Recall Bulletin

SUBJECT: Loss of Battery Charge – Replace Generator Control Module

MODELS: 2012-2013 Buick LaCrosse, Regal
2013 Chevrolet Malibu Eco
Equipped with eAssist

The Part Inspection Procedure in this bulletin has been revised. Please discard all copies of bulletin 13136A.

3600552

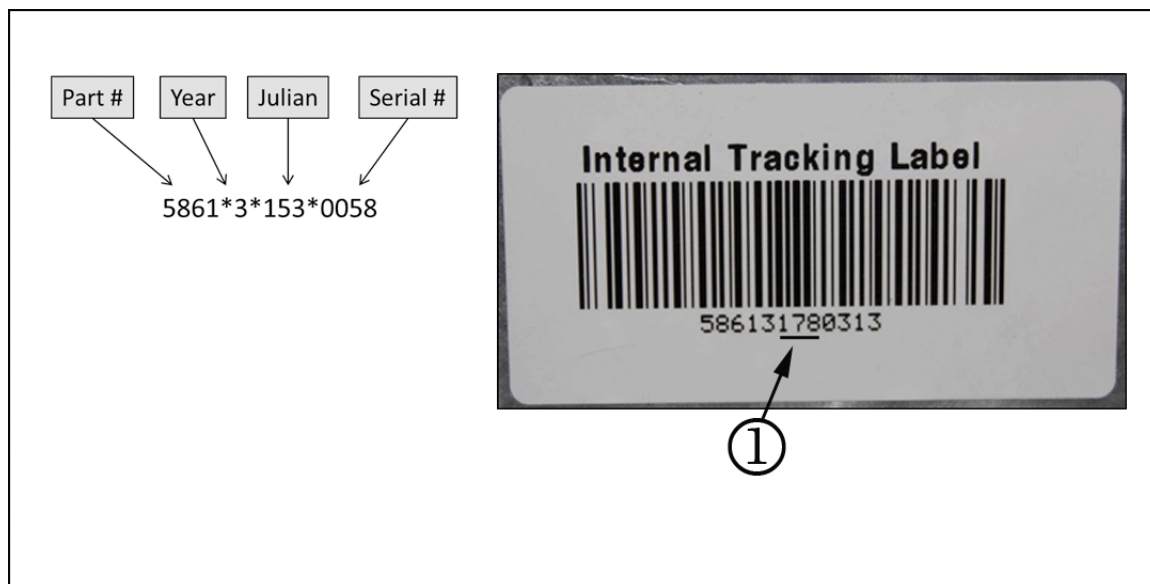
Generator Control Modules (GCM) with part number 24269448 or 24266403 require an inspection prior to installation in a vehicle. GCMs with part number 24267940 or 24267941 do NOT require inspection prior to installation in a vehicle.

Do NOT provide technicians with GCMs (p/n 24269448 or 24266403) that have a Julian date of 171 through 199. Determine the Julian date following the steps below. Return modules that fail the inspection according to Special Return Bulletin #G_0000171850.

1. Locate the barcode label on the new GCM.

- 2. Determine the Julian date (1) as shown above.
 - If the Julian date (1) is 171 through 199, proceed to step 3.
 - If the Julian date (1) is NOT 171 through 199, provide the GCM to the technician for installation in the vehicle.

- 3. Locate the Flash label on the GCM.
 - If the number on the lower right-hand side of the label (2) is 3203 or lower, do NOT use the GCM. Obtain another module and perform the inspection again.
 - If the number on the lower right-hand side of the label (2) is 3204 or higher, provide the GCM to the technician for installation in the vehicle.

3600552

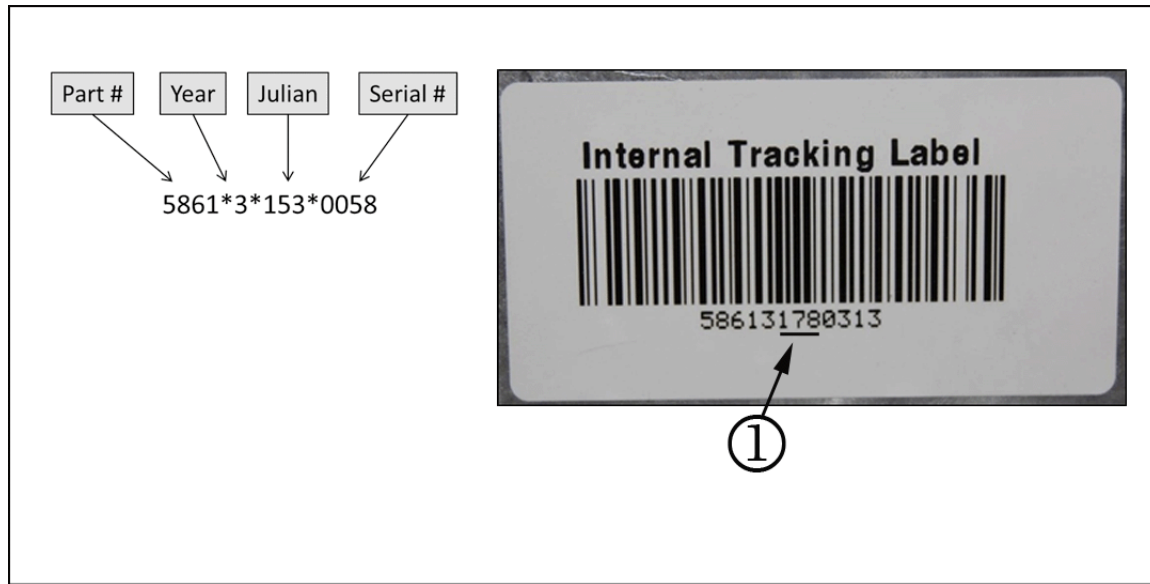
1. Locate the barcode label on the new GCM.
2. Determine the Julian date (1) as shown above.
 - If the Julian date (1) is 171 through 199, proceed to step 3.
 - If the Julian date (1) is NOT 171 through 199, install the GCM in the vehicle.

3. Locate the Flash label on the GCM.

- If the number on the lower right-hand side of the label (2) is 3203 or lower, do NOT use the GCM. Obtain another module and perform the inspection again.
- If the number on the lower right-hand side of the label (2) is 3204 or higher, install the GCM in the vehicle.
